RE: EM-ATT-034-230721 - AT&T notice of intent to modify an existing telecommunications facility located at 48 Newtown Road, Danbury, Connecticut. Denial of Request for Project Change.

RE: CSC Approval EM-ATT-0034-230721 Newtown Road
Generator Installation 48 Newtown Road, Danbury Connecticut

PROJECT TITLE:
DANBURY EAST
FA ID # 10035077

SHEET TITLE:
SITE PLAN & EQUIPMENT LAYOUT

PROJECT NUMBER: 57537
 SHEET NUMBER: A-1

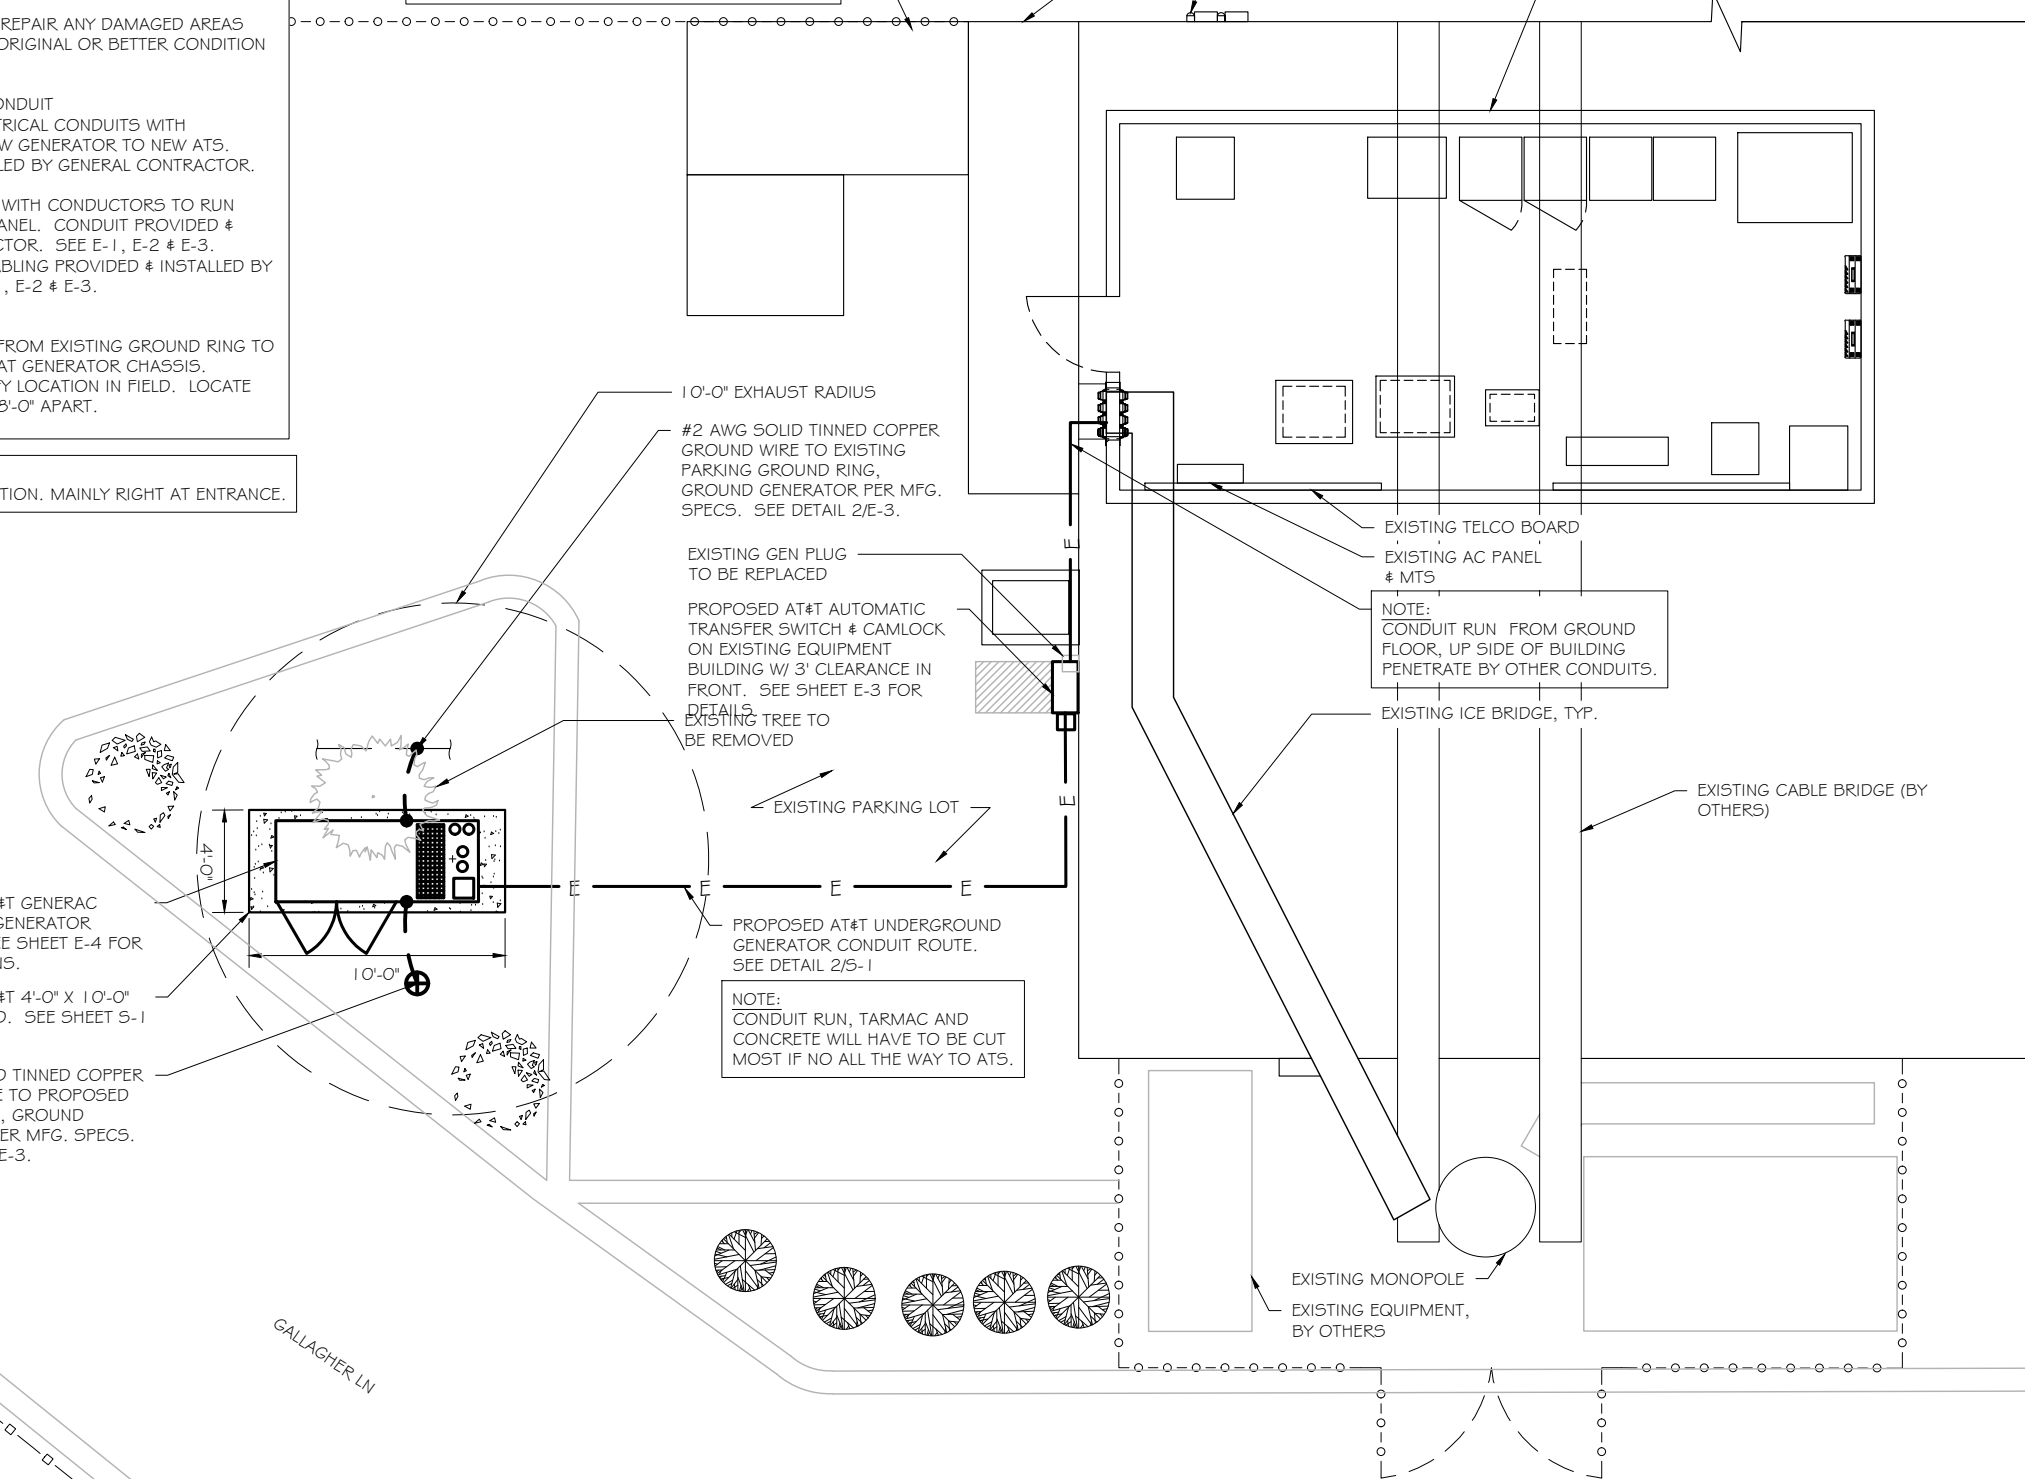
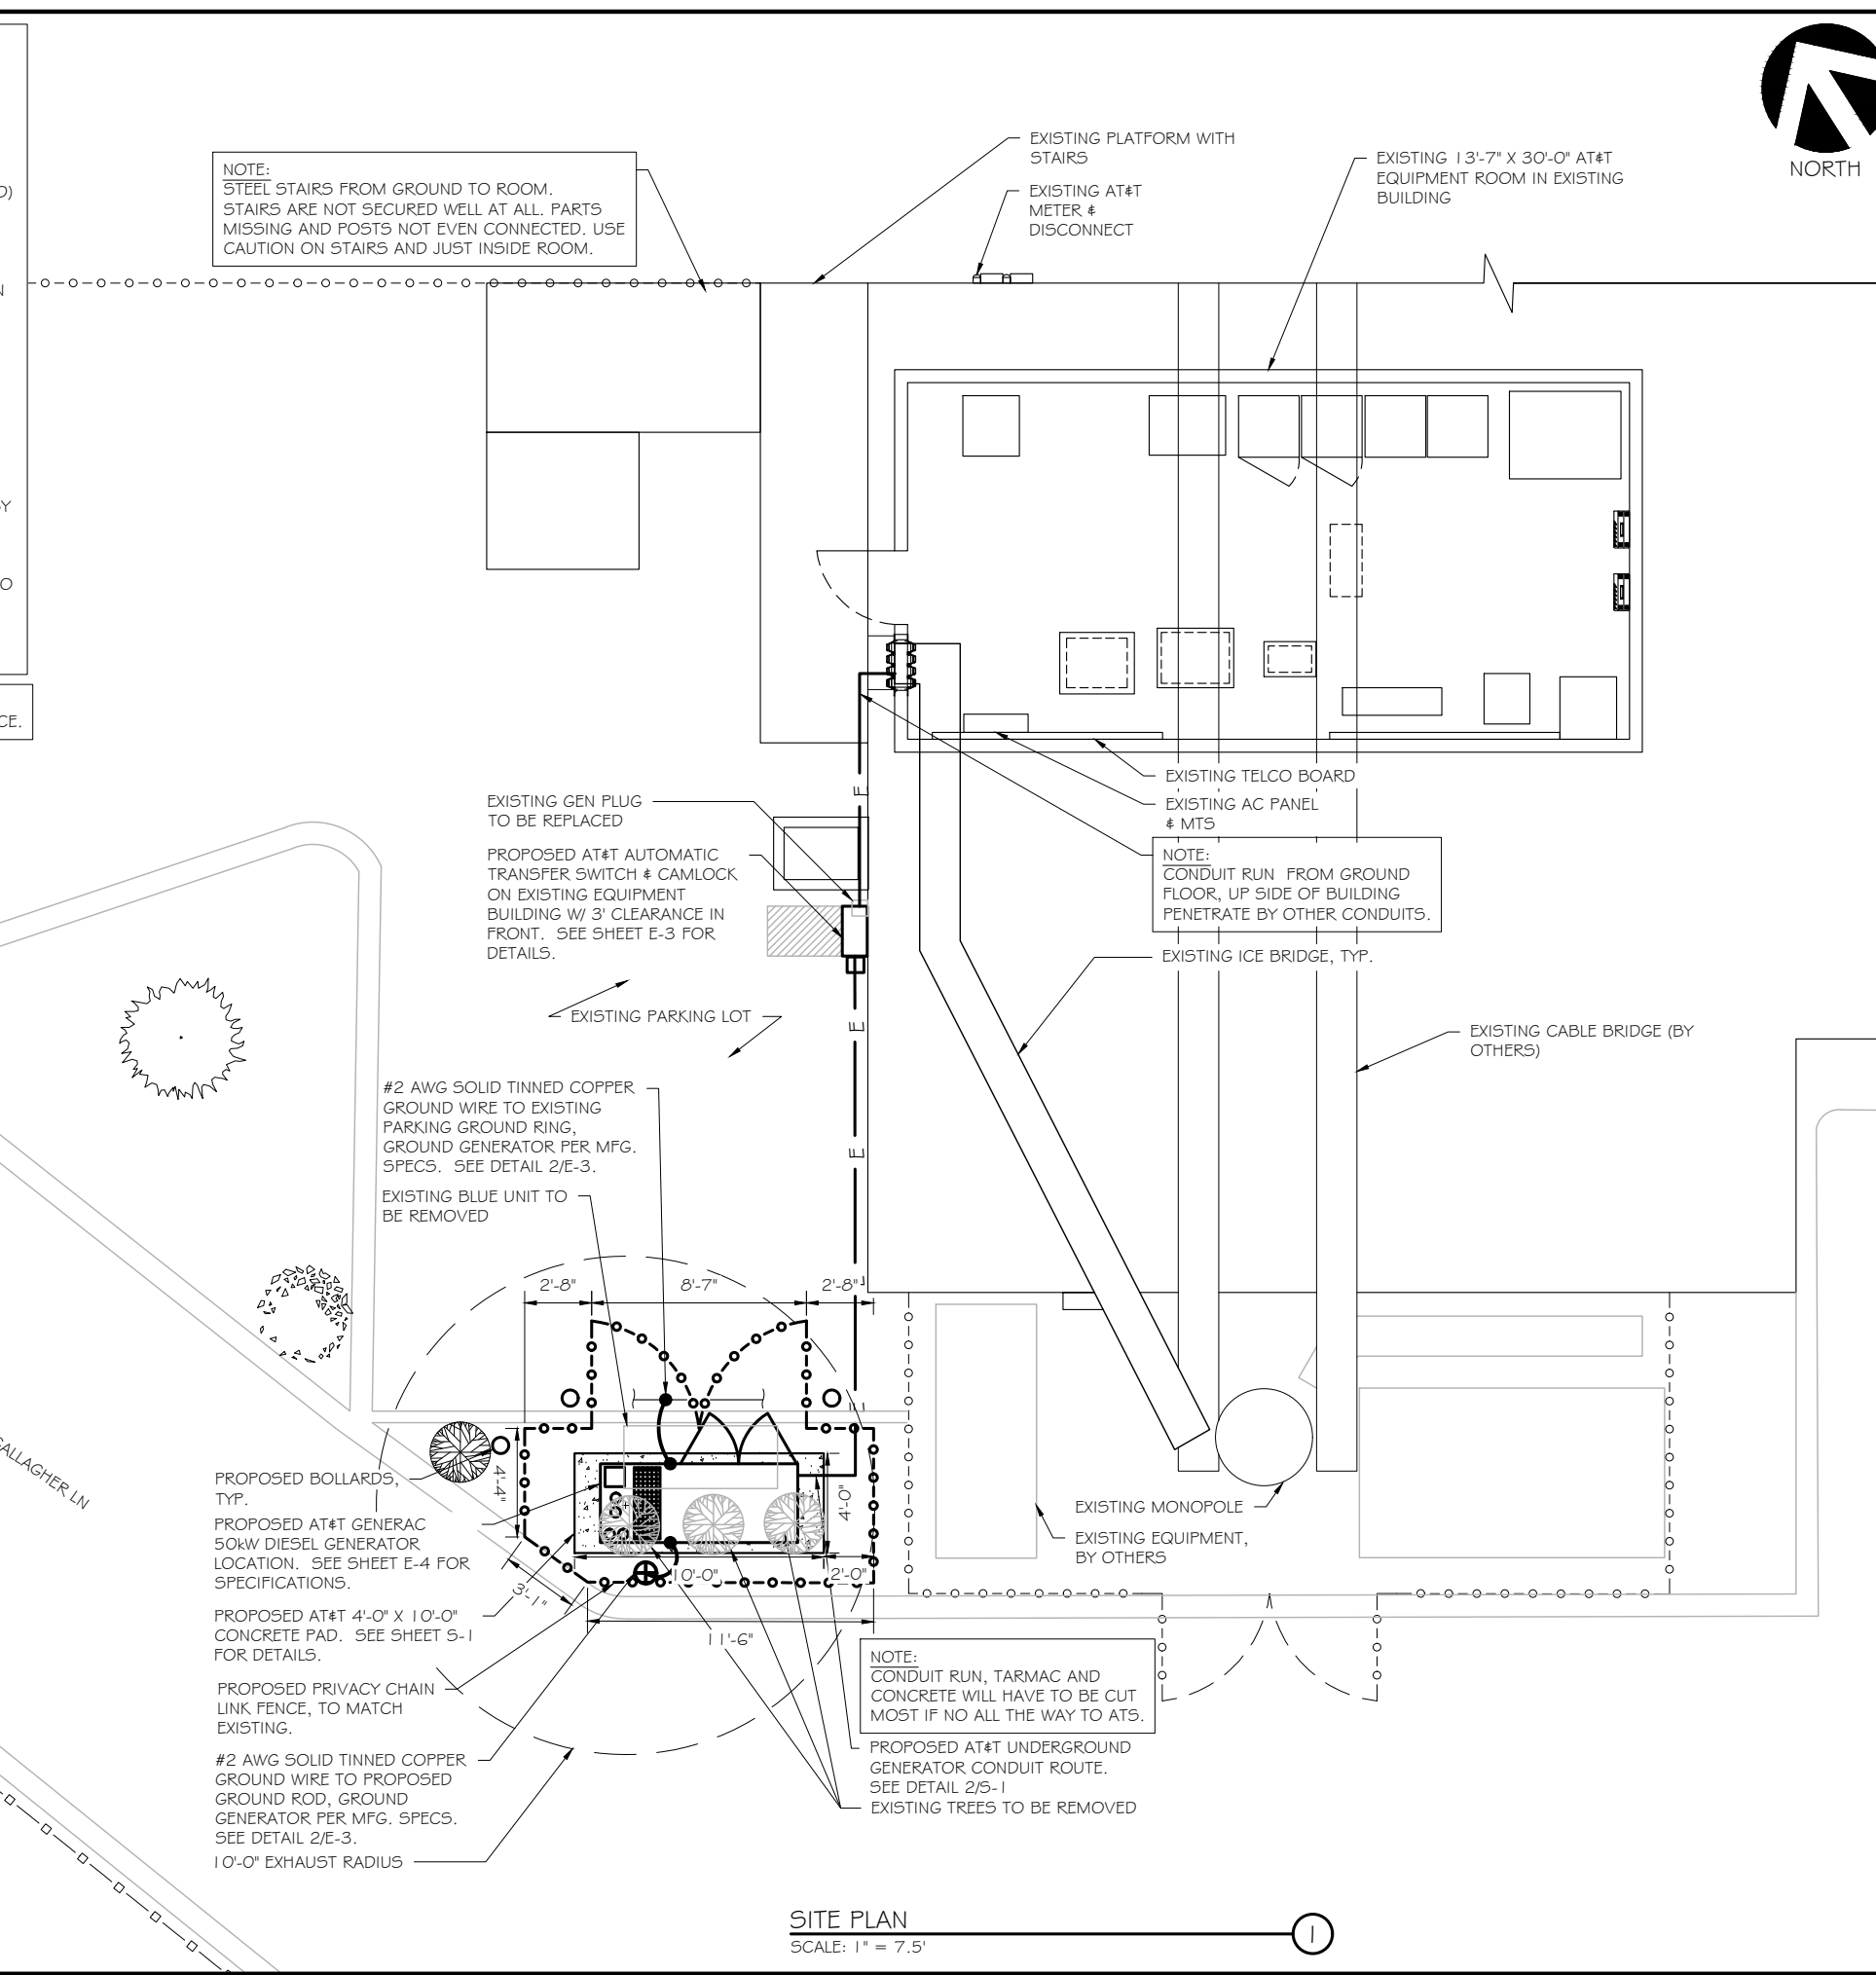
The Connecticut Siting Council (Council) is in receipt of your email of November 8, 2023 regarding the proposed change to the location of the emergency backup generator. The Council hereby denies your request.

Staff has reviewed this request for a project change and identified a deficiency in compliance with the criteria set forth in RCSA Section 16-50j-72. Page 1 of the July 21, 2023 request states that the generator would be installed "within the existing grade-level fenced equipment compound." Additionally, the Scope of Work section on the first page of the Site Plans states AT&T would "add a standby generator...to existing AT&T equipment area." The November 8, 2023 request depicts the change to the location of the emergency backup generator due to a property owner request; however the location of the generator appears to require an extension of the lease area as evidenced by the removal of vegetation, elimination of parking spaces and addition of fencing.

This project change request to extend the lease area of an existing site is not consistent with the criteria set forth in RCSA §16-50j-72. Such a request is properly submitted to the Council in the form of a petition for a declaratory ruling.

In accordance with Regulations of Connecticut State Agencies Section 16-50j-73, I am informing you that the Landlord has changed the location of the generator. See attached CSC approved location and new location.

Therefore, this request does not qualify as a project change request and it is hereby rejected on that basis. The Council recommends that AT&T submit a petition for a declaratory ruling.
